**City of Portland, Maine – Building or Use Permit Application** 389 Congress Street, 04101, Tel: (207) 874-8703, FAX: 874-8716

Permit No: **000673**

BUILDING PERMIT REPORT

REASON FOR PERMIT: to erect a 12x20 above ground pool

340-F-  
001

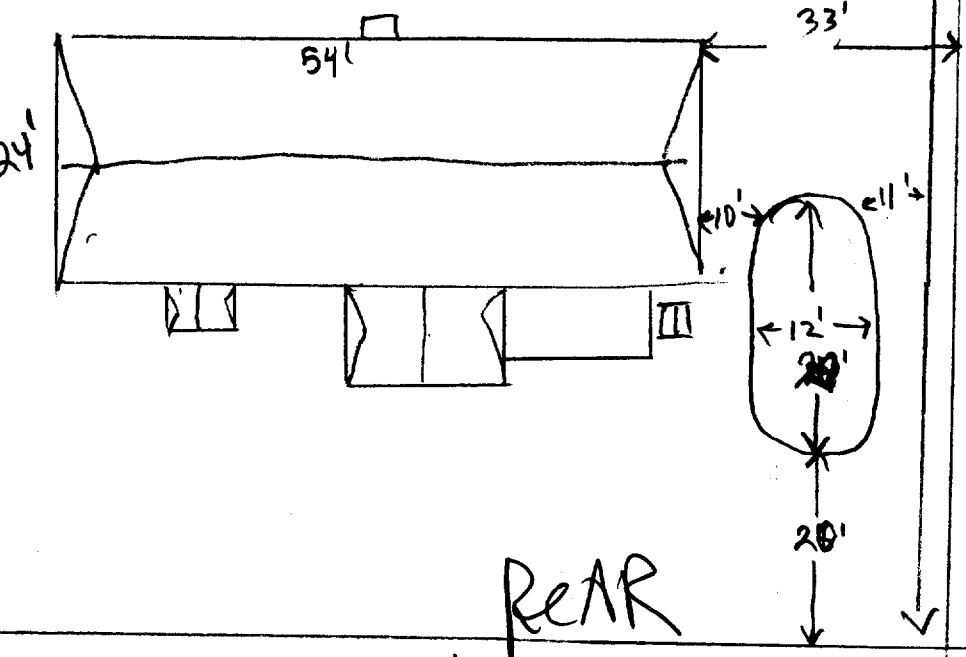
10' Required from  
Side & Rear property  
lines  
10' required from principal  
structure
